DOUBLE SUPPORT TIE – Original Design Reinstatement

Preformed Line Products Double Support Tie

August 2016
SP3387

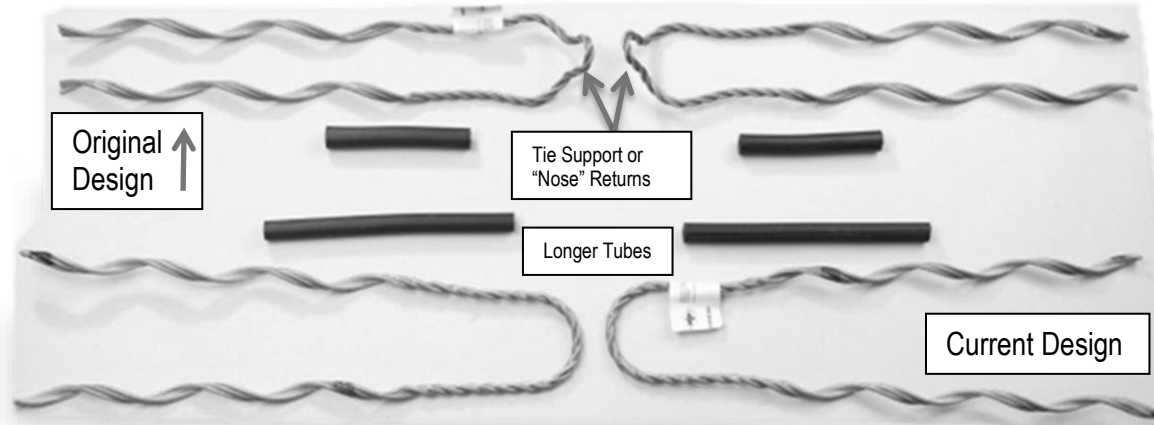
After feedback and consultation with customers, Preformed Line Products is changing the Double Support Tie for smaller conductor ranges only (e.g., 0.245” through 0.755”). In fact, PLP is bringing back the “original” design for these smaller conductor ranges, which includes a “nose” or support loop. For conductors outside of this range, the nose-less current design is appropriate, as the tie/insulator interface is designed to increase conductor connection security.

The catalog numbers remain the same, so there is a chance that a mix of these two designs could exist in customer or distributor stock. However, the two versions work seamlessly together and both versions provide proper performance with no loss of holding strength.

The application procedure for the reinstated/original version (SP3386) can be found at www.preformed.com. In addition, PLP has test reports of the tie performance available upon request (TR-882E and TM-171-E).
